Re: Farmers Creek Shared Pathway Works. Ref: 280120

Thank you for forwarding a copy of the concept plan for this section of the pathway and the opportunity to express my comments or concerns on this proposal.

Photographs taken on 5 February 2020 – property 174 Inch Street, Lithgow. Access to garage from Burton Street.

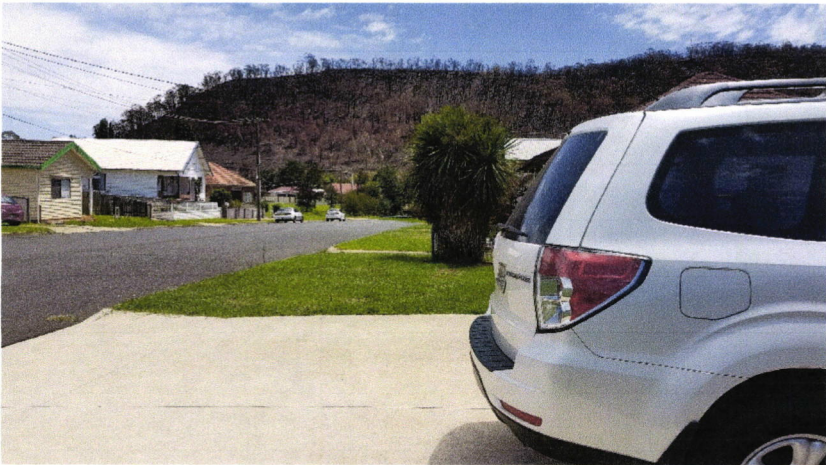
By the time a cyclist and driver see each other they may not have sufficient time to react to avoid an incident. I have attached photographs of the line of sight from my driveway when reversing from my garage as an example. Some of the residents in Burton Street would have less line of sight.

Line of sight looking towards Inch Street when reversing from garage.

Line of sight towards creek when reversing from garage.

Position of vehicle when above photo taken.

Line of sight when looking towards creek is not clear until vehicle is directly on what would be shared pathway
